**ADDENDUM NO. 2**

**For: Elementary School # 38  
522 Brookewater Boulevard  
Rosenberg, TX 77471  
for  
LAMAR CISD  
3911 Avenue I  
Rosenberg, TX 77471**

**ADDENDUM DATE: January 10, 2025**

**PROJECT NO: 24-028**

100% CONSTRUCTION DOCUMENTS  
**A1.00**  
ARCHITECTURAL SITE PLAN

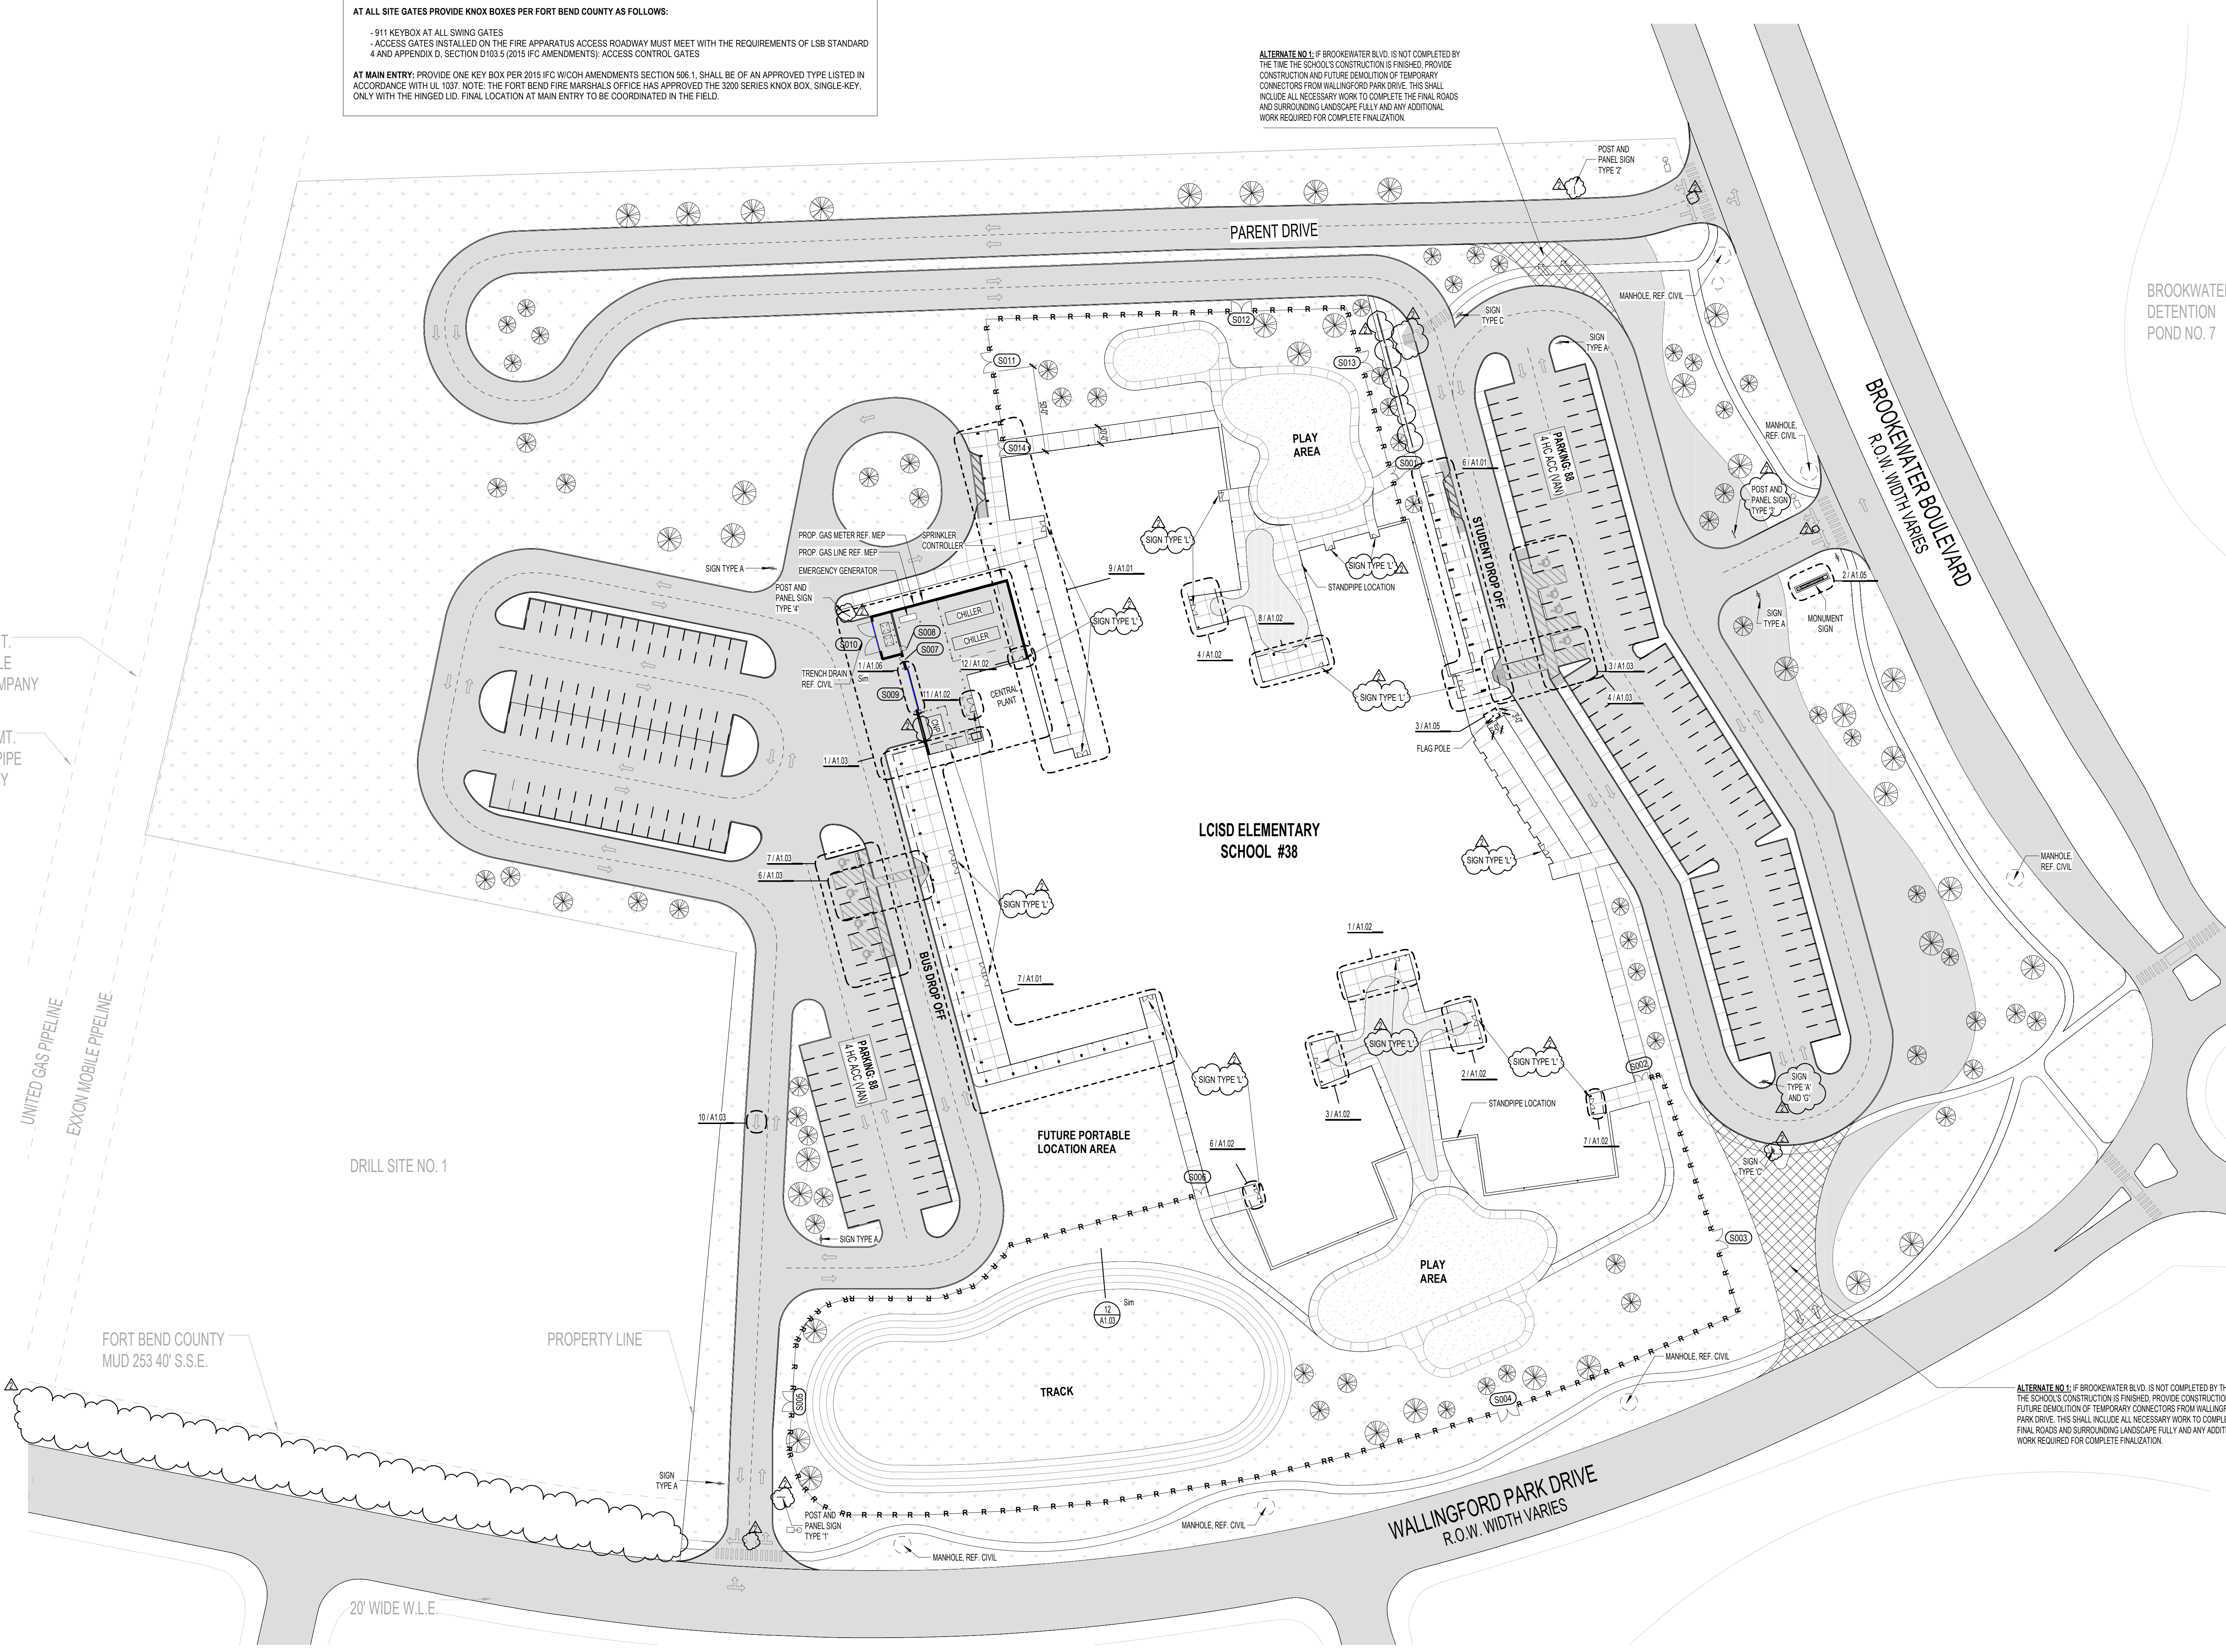
ITEM	SHEET	DESCRIPTION
D2-1	G0.04	Revised room C109 name from "CENTRAL PLANT" to "CHAIR STORAGE", TYP.
D2-2	G0.04	Room C108E Storage added in area C. Door added to room C108E
D2-3	G0.04	FEC added in Platform in Area C.
D2-4	G0.04	Fire Assembly Legend: Floor/Ceiling - UL Assembly No P902: 1HR Structural Frame Rated 1HR Added
D2-5	G0.05	Fire Assembly Legend: Floor/Ceiling - UL Assembly No P902: 1HR Structural Frame Rated 1HR Added
D2-6	G0.05	UL Assembly No P902 added to Floor/Ceiling Assembly in Mezzanine
D2-7	G0.05	Fire Assembly Legend: Floor/Ceiling - UL Assembly No P902: 1HR Structural Frame Rated 1HR Added
D2-8	G0.06	UL Assembly No P921 added to Roof Assembly in Area C
D2-9	G0.07	Revised room C109 name from "CENTRAL PLANT" to "CHAIR STORAGE", TYP.
D2-10	G0.07	Note added at Overhead Coiling Grilles in Corridors
D2-11	G0.08	Design No P921 Details Added
D2-12	A1.00	Removed stop sign from center of roadway

D2-13	A1.00	Sidewalk located west of property line, facing Wallingford Park Drive deleted
D2-14	A1.00	Added callout for sign type 'L'
D2-15	A1.00	Added post and panel sign '2' at south entrance
D2-16	A1.00	Added post and panel sign '2' at parent drive
D2-17	A1.00	Modified callout for signage to "POST AND PANEL SIGN TYPE '3'
D2-18	A1.00	North Arrow added to View
D2-19	A1.00	Added bike racks along student drop off
D2-20	A1.00	Added ramp on the northside of student dropoff
D2-21	A1.00	Added Do Not Enter Sign at end of student drop off
D2-22	A1.00	Added post and panel sign at SPED drop off
D2-23	A1.00	Added louvers to mechanical yard
D2-24	A1.00	Updated sizing on gate schedule for gate S009. Revisions made to "DESCRIPTION" of gate S007
D2-25	A1.02	Downspouts modified. Metal soffit span directions modified.
D2-26	A1.02	Detail 9 soffit span direction modified and soffit material modified to be AWC
D2-27	A1.02	Soffit span directions modified on details 1, 2, 3, 4, 5, 6, 7, 8, 9, 10, 11, 12

100% CONSTRUCTION DOCUMENTS  
**A1.03**  
ENLARGED  
ARCHITECTURAL SITE  
PLANS

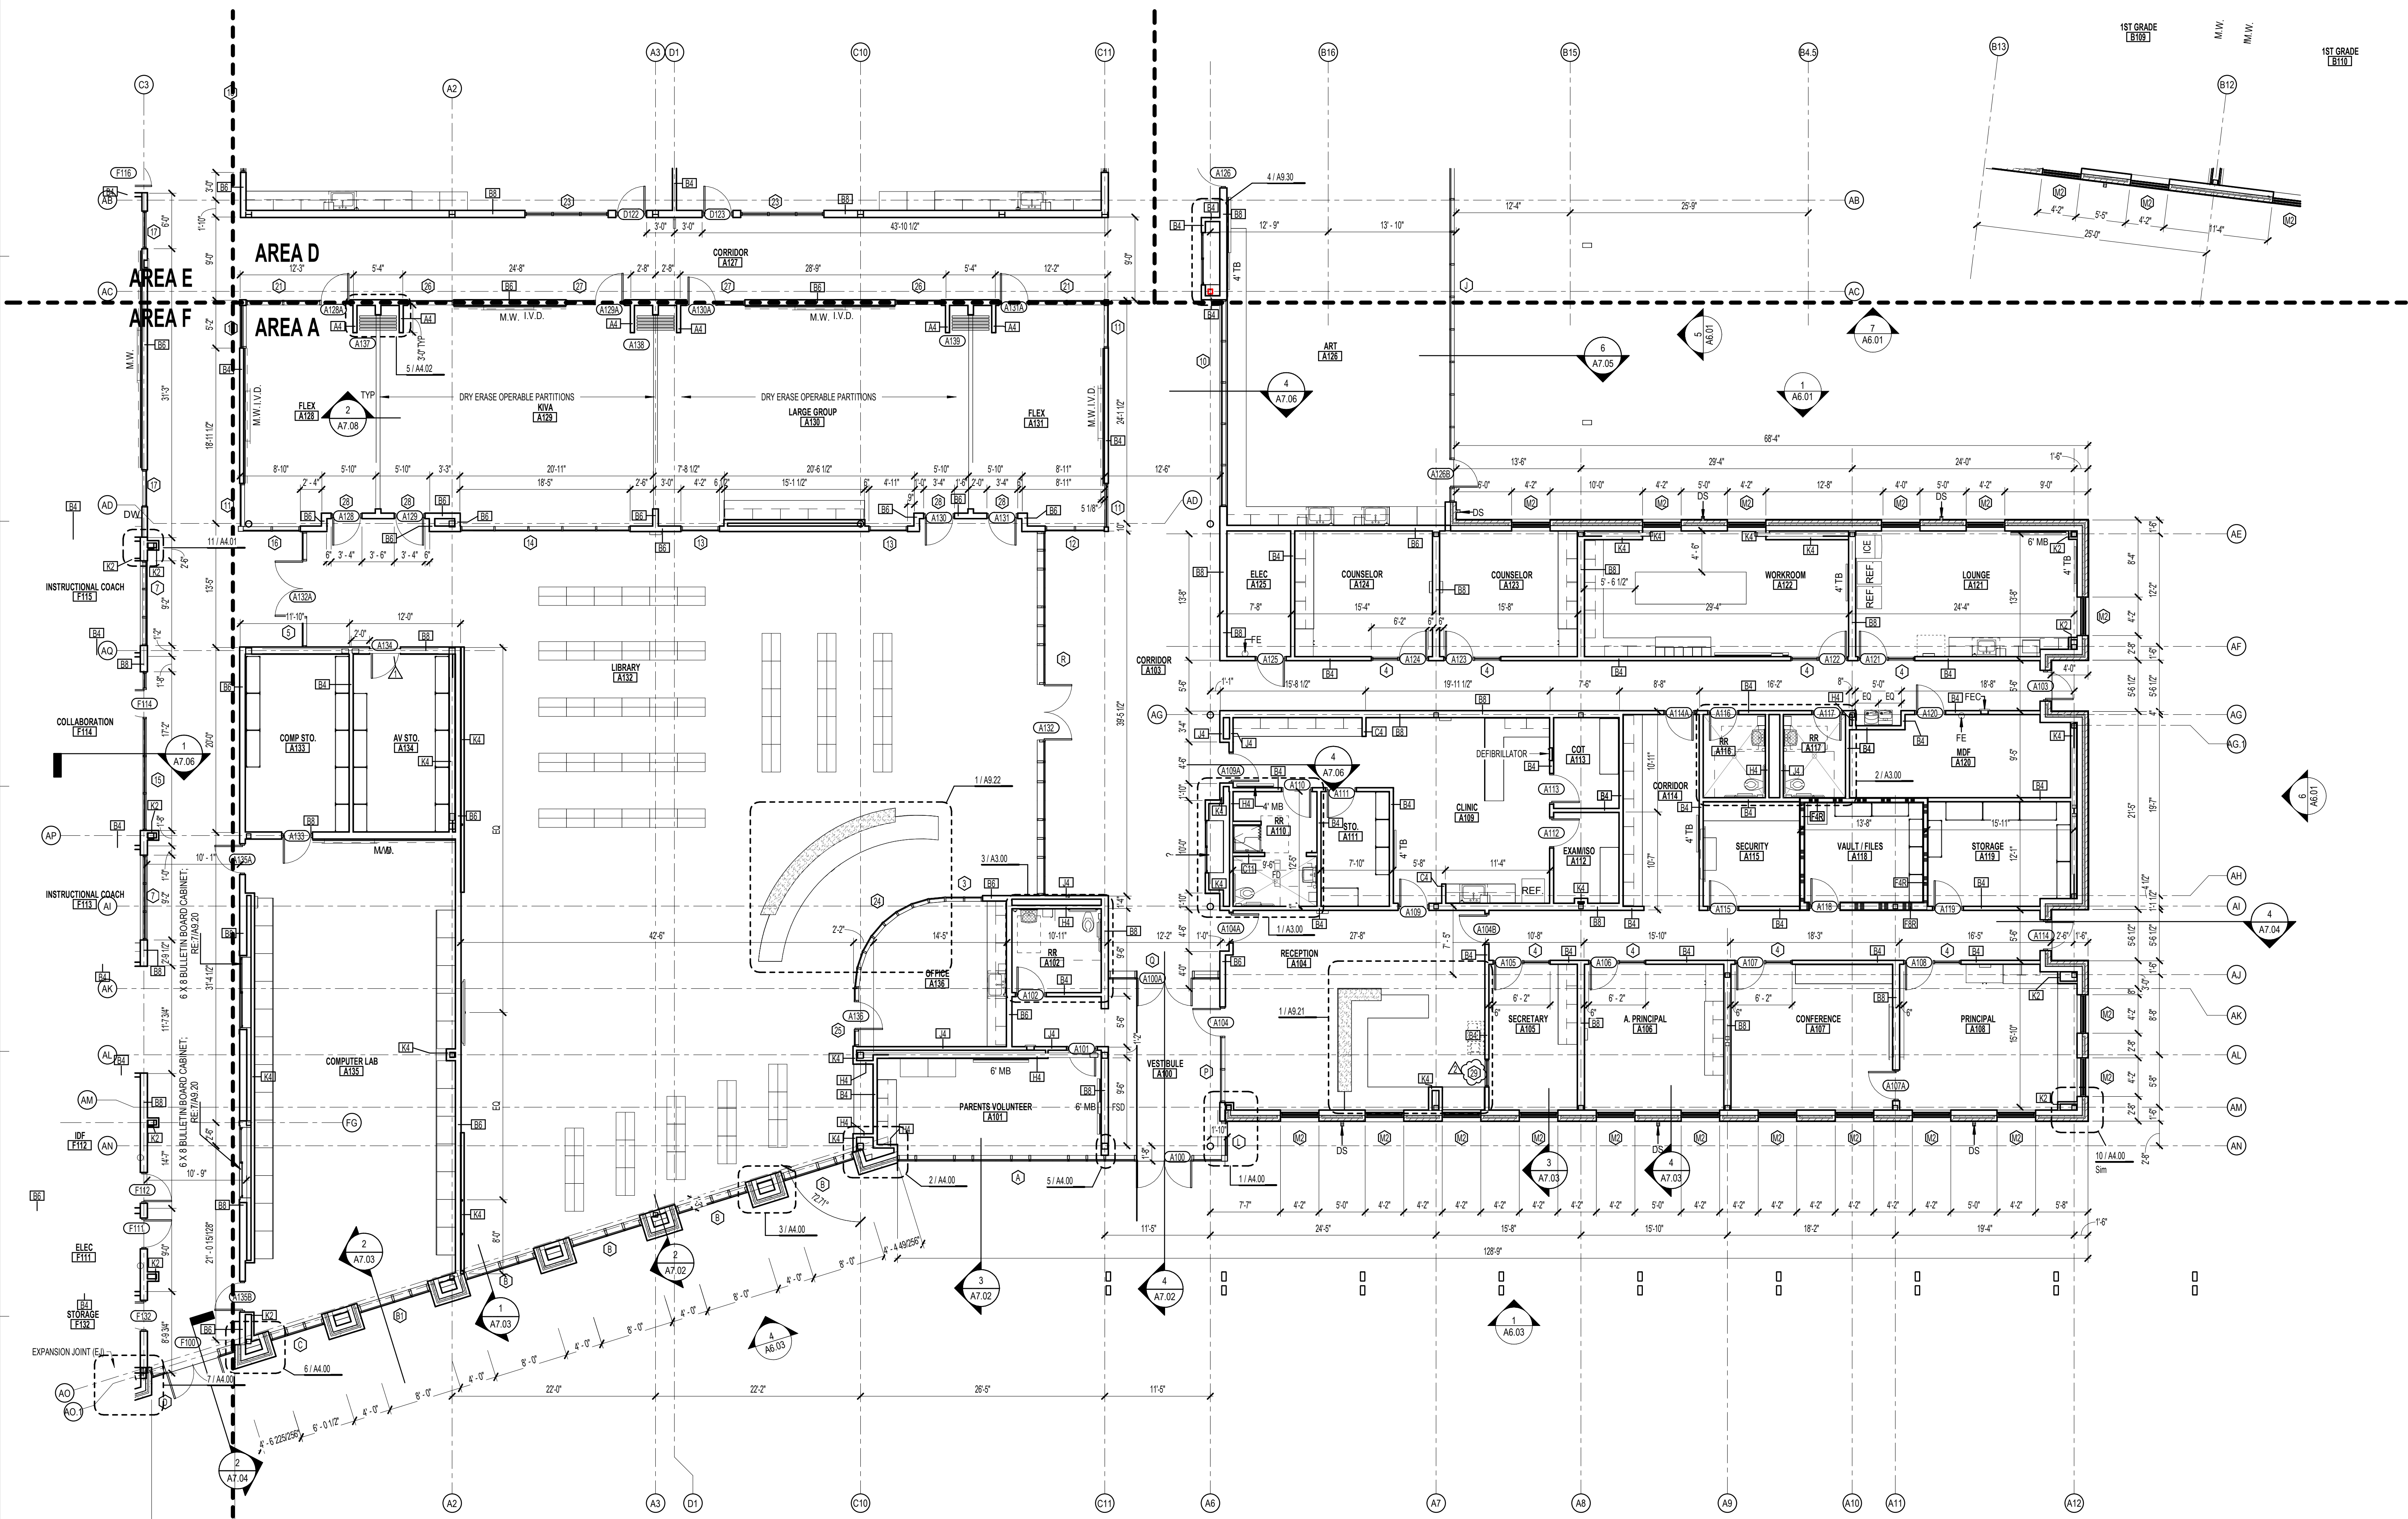
D2-28	A1.03	Modified post and panel sign types
D2-29	A1.03	Detail 12 Modified
D2-30	A1.03	Added and revised notes regarding bollards on detail 1
D2-31	A1.03	Modified Gate S010 to be double swing gate
D2-32	A1.03	Updated tags on for gates on detail 1
D2-33	A1.05	Details 1, 2, 5, 7 & 8 Modified
D2-34	A2.01A	Tagged frame window frame by reception desk
D2-35	A2.01B	Added callout for wall section 5/A7.08 near door C121
D2-36	A2.01C	Revised room C109 name from "CENTRAL PLANT" to "CHAIR STORAGE", TYP.
D2-37	A2.01C	Room C108E Storage added in area C. Door added to room C108E
D2-38	A2.01C	FEC added in Platform in Area C.
D2-39	A2.01E	Standpipe note removed from corridor E102
D2-40	A5.00	Downspouts in area B and C modified.
D2-41	A5.00	Called out downspouts on multiple canopies
D2-42	A5.01A	Called out downspouts on multiple canopies
D2-43	A5.01B	Called out downspouts on multiple canopies
D2-44	A5.01C	Called out downspouts on multiple canopies
